3.1 CAD CALCULATIONS CURRENT MODIFICATION AREAS

DEPARTMENT ITEM 3.2:

DEPARTMENT ITEM 4.1:

4.3 SEPP SOLAR ACCESS AND CROSS VENTILATION

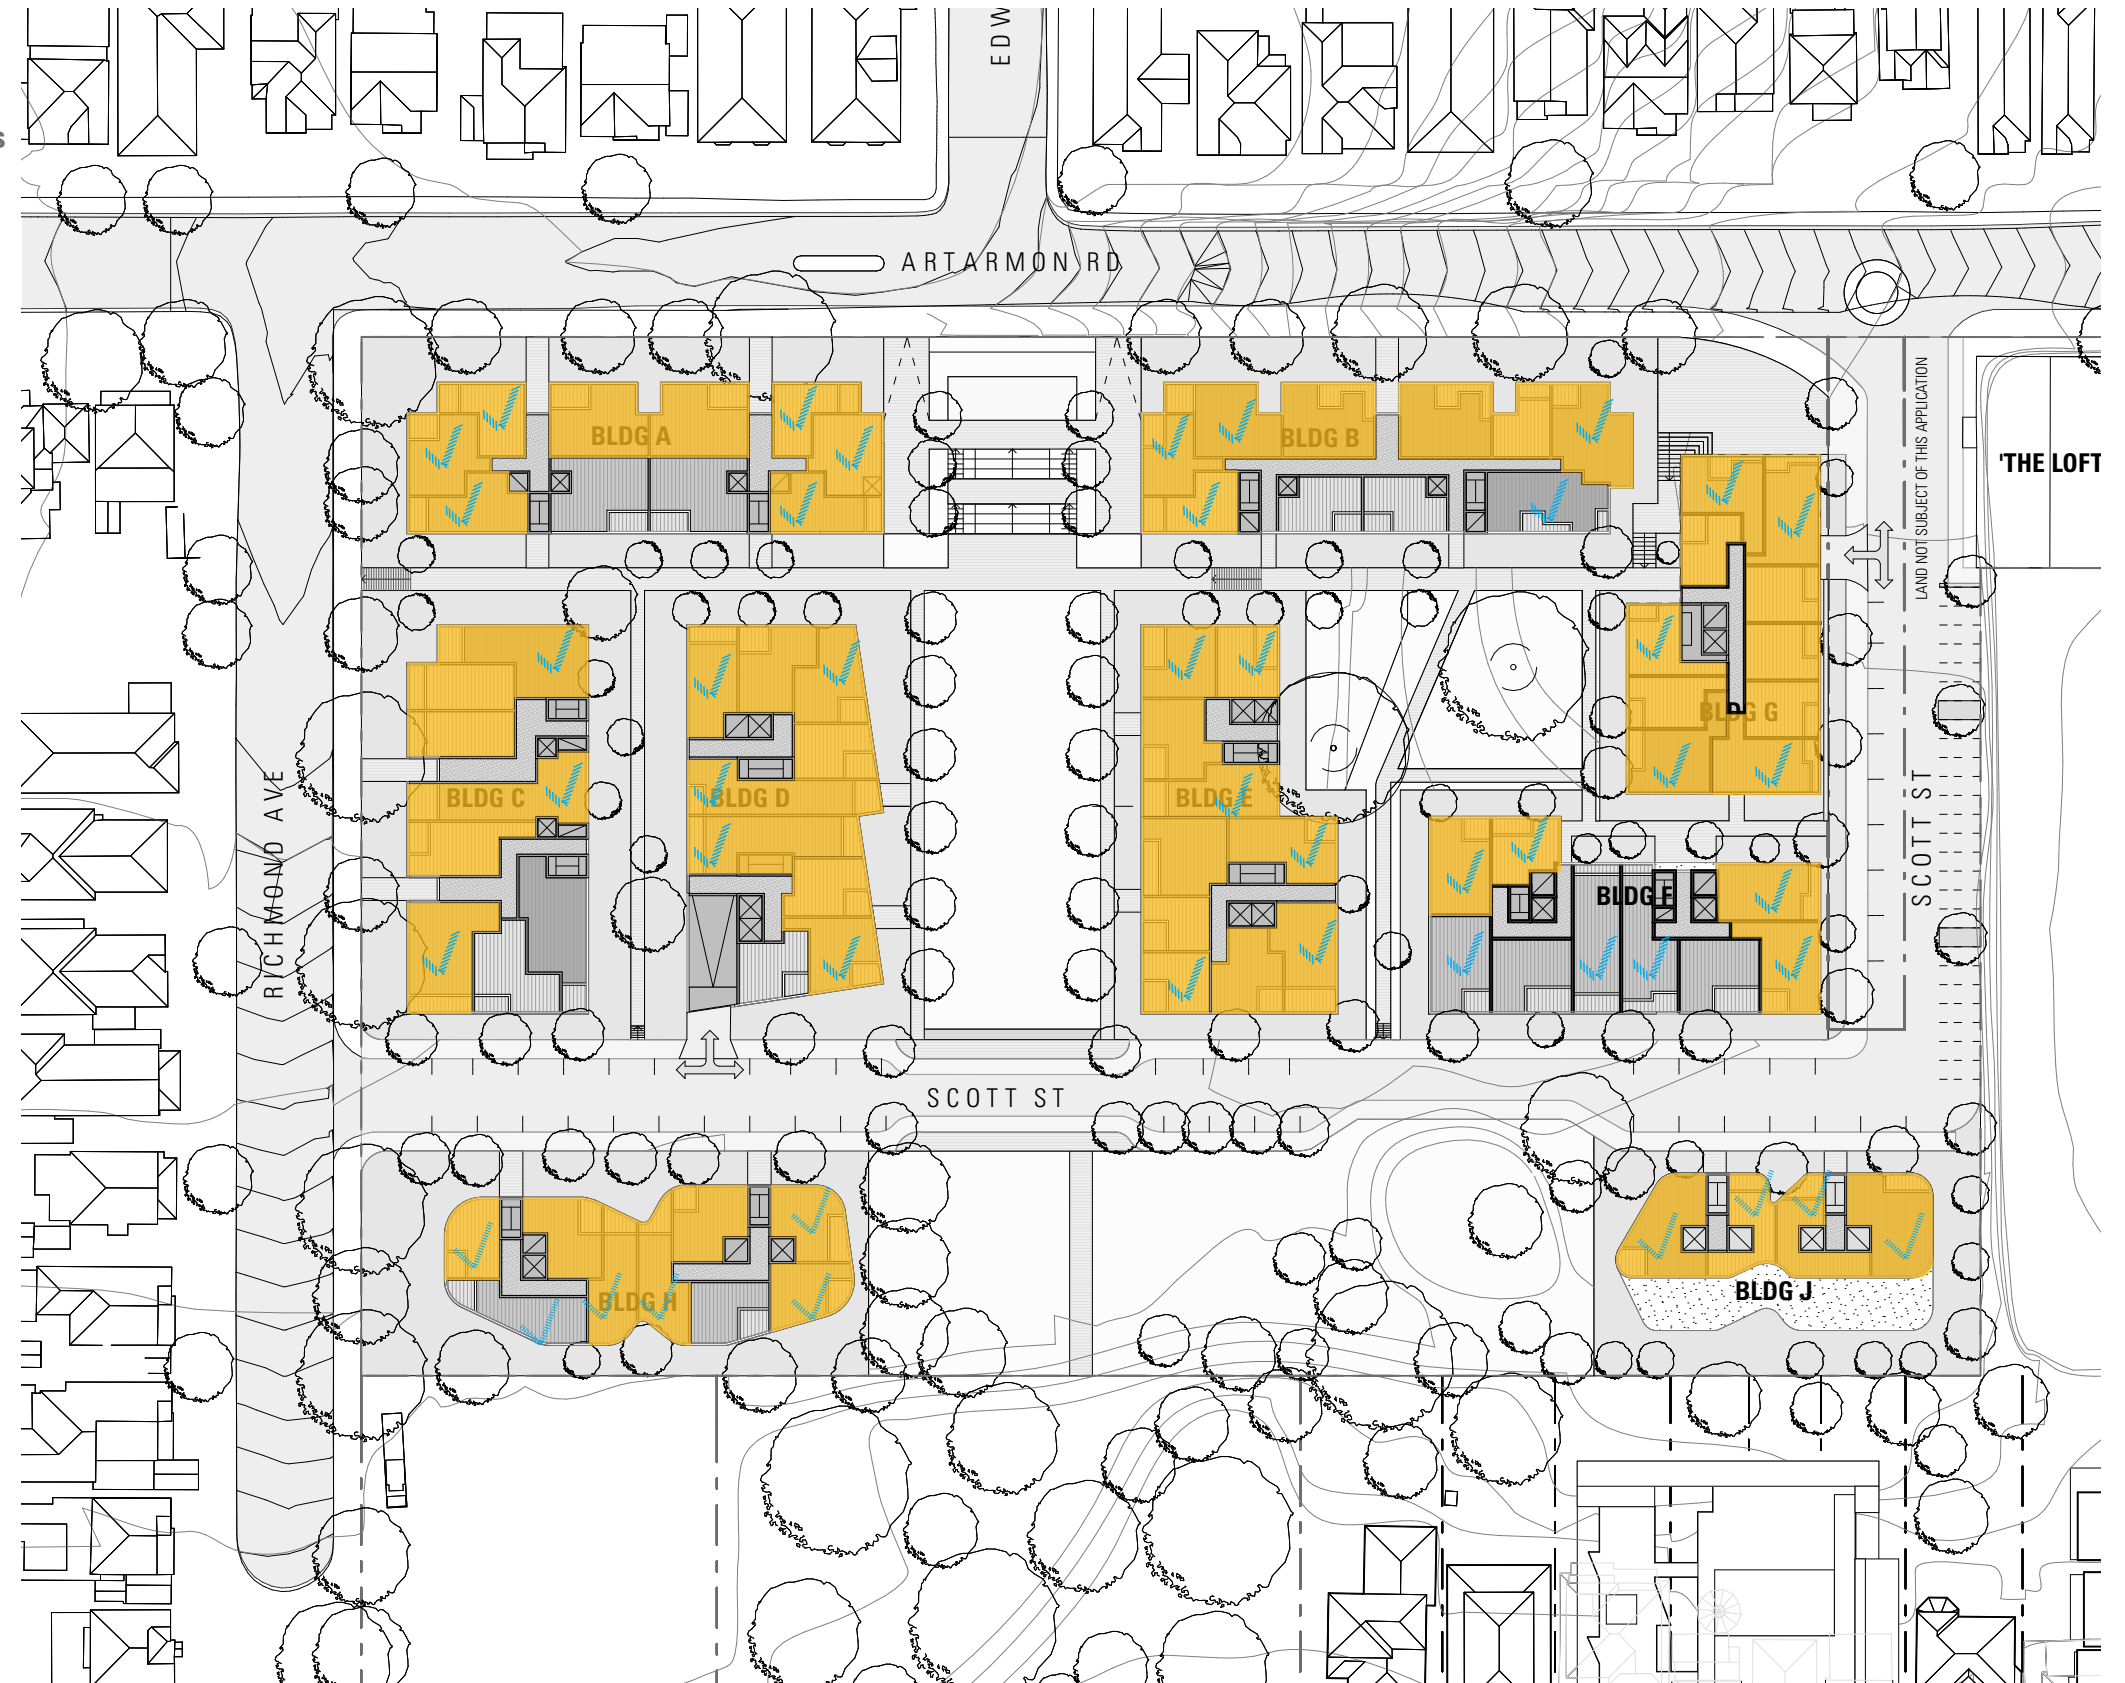
“Provide indicative floor plans which demonstrate how the proposed building envelopes achieve solar access and cross ventilation.”

This typical floor plan highlights the SEPP65 - ADG compliances for direct solar access and cross ventilation.

Overall the masterplan achieves a minimum of 70% compliant units with direct solar access and a minimum of 60% of cross ventilated units as required by SEPP65 - ADG.

6.1 BUILDING J IMPACT ON WALTER ST APARTMENTS

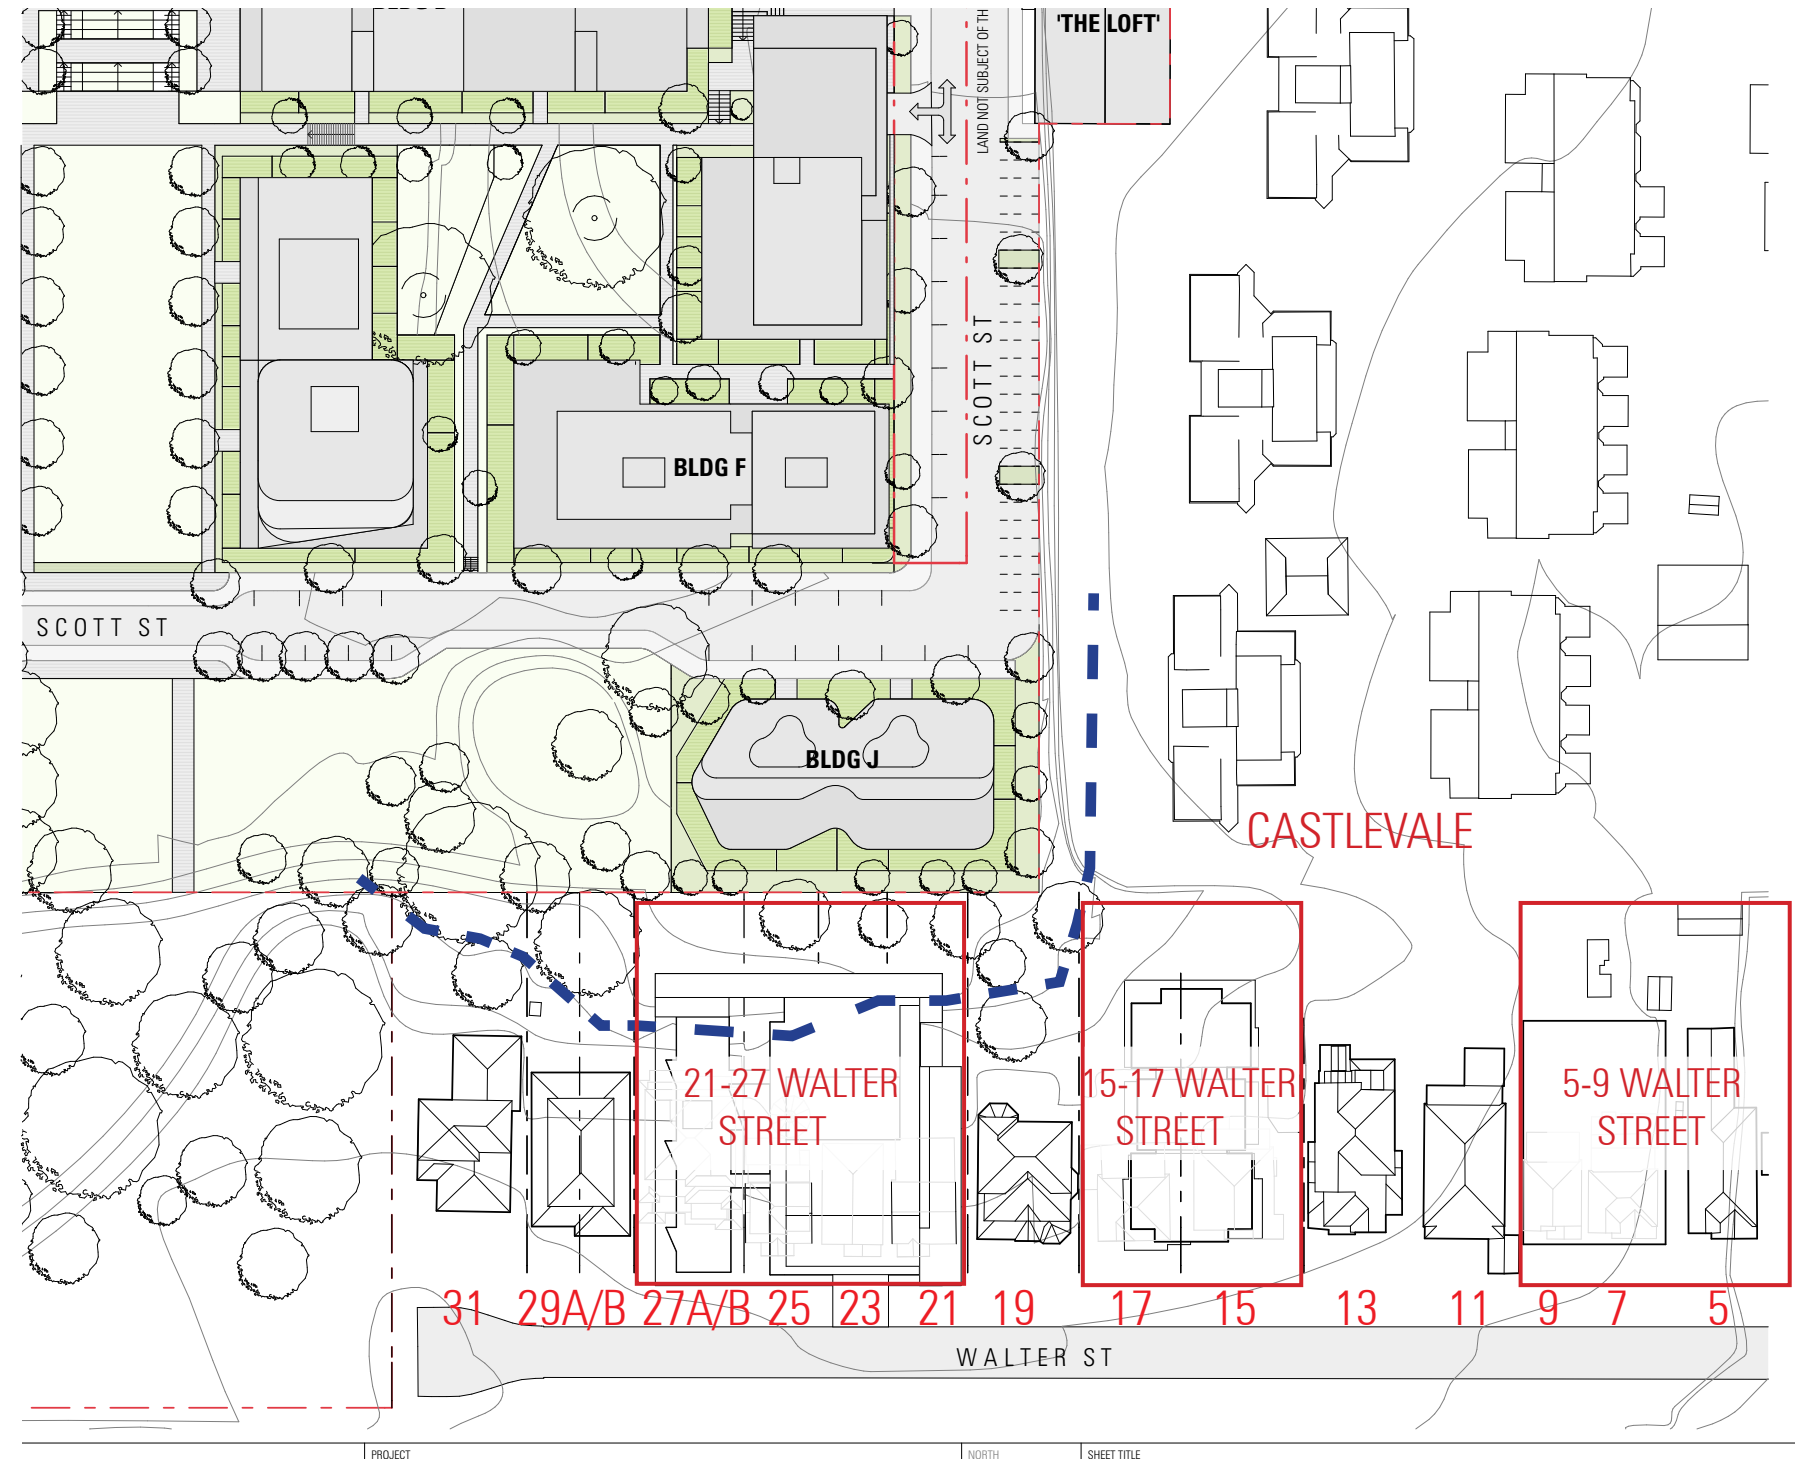
“Demonstrate how the proposed ensures the recently approved medium density development along Walter Street maintain adequate solar access having regard to the design criteria of the Apartment Design Guide. Where impacts to these properties are greater than the approved development consideration should be given to refinements to building envelopes to ensure there is no additional adverse impacts on the amenity of these properties.”

Walter street, which currently consists of single or two level detached houses or semis, is zoned to allow for multi residential development with a height control of 12m and FSR control of 0.9:1. Properties on Walter St directly below the site are separated by a steep escarpment (indicatively shown in blue). Properties further to the east of the site below Castlevale are on relatively flatter land as seen in the contours.

Walter Street currently has an approved development application for multi residential apartments at 5-9, 11-13, 15-17 and 21-27 Walter St. The approved DA for 21-27 Walter St, in closest proximity to building J (directly below the proposed site) states solar compliance with building J is achievable.
